LANDSAPE AND VISUAL APPRAISAL ADDENDUM

Cotswold Homes Ltd

Land off Biddestone Lane, Yatton Keynelly

Ref: PL/2025/03672

Photo Viewpoint A: View from public footpath WT/YKEY/15 to south east of the site

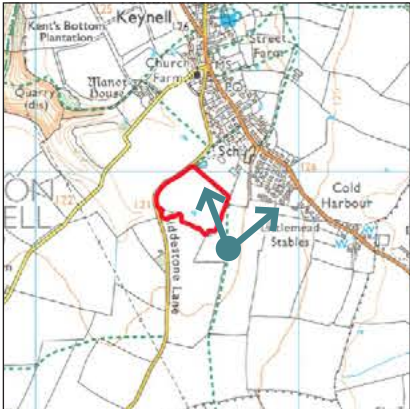
- 3.14 The comments note the lack of inclusion of a viewpoint from PRoW YKEY15 to the east of the site.

"It is disappointing that the only viewpoint provided in the LVA on this side of the site is viewpoint 5 over 600m from the site boundary with several intervening field boundaries. An additional viewpoint from YKEY15 within the adjacent field to the site would have been helpful

to understand how prominent the site would likely be in the context of the settlement boundary of Yatton Keynell and especially considering the recently completed development to the east of the settlement and be able to make a more informed judgement of the potential landscape visual impacts."

- 3.15 Prior to undertaking the LVA site visit, the LPA were consulted regarding the location of viewpoints in order to agree viewpoint locations to be included within the LVA. A response was not received. At the time of the site visit, the field immediately to the east of the site boundary was heavily vegetated making access difficult. The field beyond this along the PRoW route was filled with a crop which reached above head height limiting any opportunity of obtaining a viewpoint towards the south eastern corner of the site. This is illustrated within Figure 1, Viewpoint A which is attached to this document. The image was taken during the site visit in October 2024. The site is located to the left of the image with views limited by the vegetation but the recent development at Drovers Green to the north is visible. The location of Viewpoint 5 was selected to illustrate how the intervening field boundary vegetation limits views towards the site from along the footpath route as it leads north towards the site.
